BURNETT RIVER FLOODPLAIN ACTION PLAN

COMMUNITY REFERENCE GROUP MEETING

MINUTES

Preliminary Mitigation Options for MCA Regional Bridge Upgrades

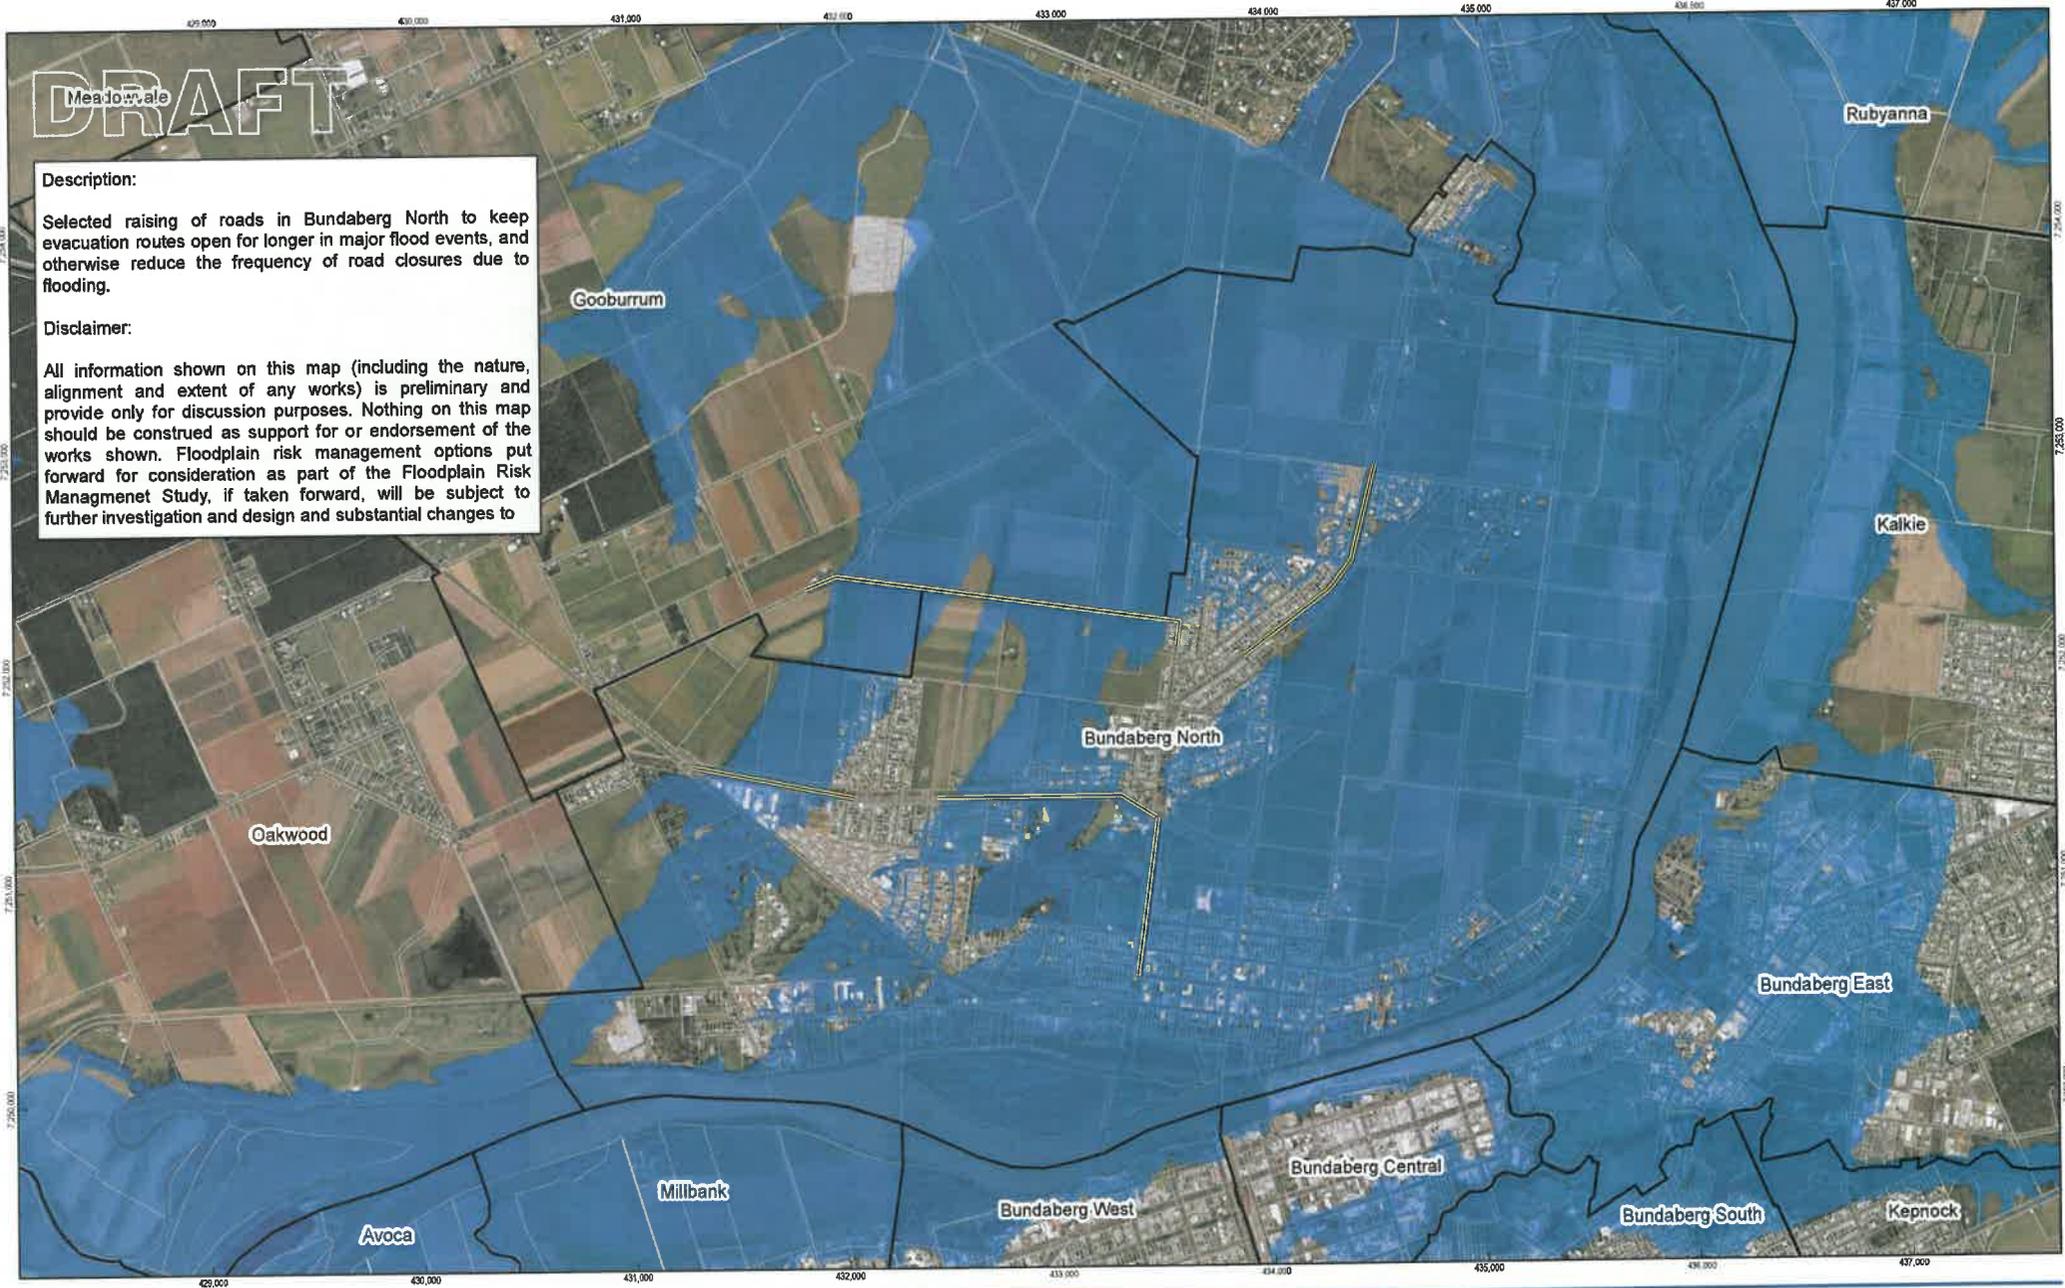
Helen Dayman drew the Meeting's attention to option 38 to upgrade regional Bridges and enquired about the modelling undertaken to date. She stated that whilst the community would like Booyal Crossing upgraded, given the width and velocity of flood water, she did not think it would be realistic to construct a bridge. However, raising the crossing a couple metres above regular flood height and heights experienced during Paradise Dam releases, would offer great benefit to the community. It was noted that Pine Creek, Cherry Creek and Log Creek should be included. Dan Copelin advised that he could make a preliminary recommendation on what heights the bridges/crossings should be subject to additional hydraulic work and agreed that there would be substantial benefit received from modest upgrading of bridges/crossings in these regional areas. At this stage, the Meeting discussed the possibility of upgrading a road through the State Forest and private property via Promiseland Road to be used in times of evacuation in lieu of upgrading bridges/crossings over Pine Creek and Cherry Creek.
